FINAL PRODUCT/PROCESS CHANGE NOTIFICATION #16476

Issue Date: 19-May-2010

TITLE: Qualification of Serial I²C EEPROM devices CAT24C04, CAT24C08, CAT24C16, CAT24C32 and CAT24C64 for fabrication at ON Semiconductor's Gresham, Oregon Wafer Fab, and marking updates for product using Gresham die, to differentiate from product using the current OKI Semiconductor die.

1) PDIP 8LD (L)

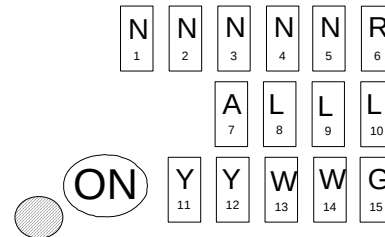
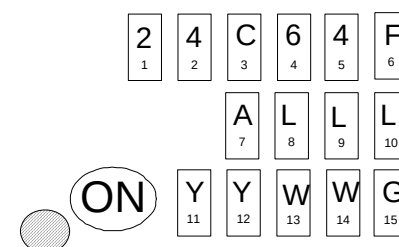
New Gresham die

- 1-5: Device name (5 char)
- 6: Production Revision
- 7: Assembly location
- 8-10: Assembly Lot Number
- 11-12: Production Year
- 13-14: Production Week
- 15: Pb-free (fixed as "G")
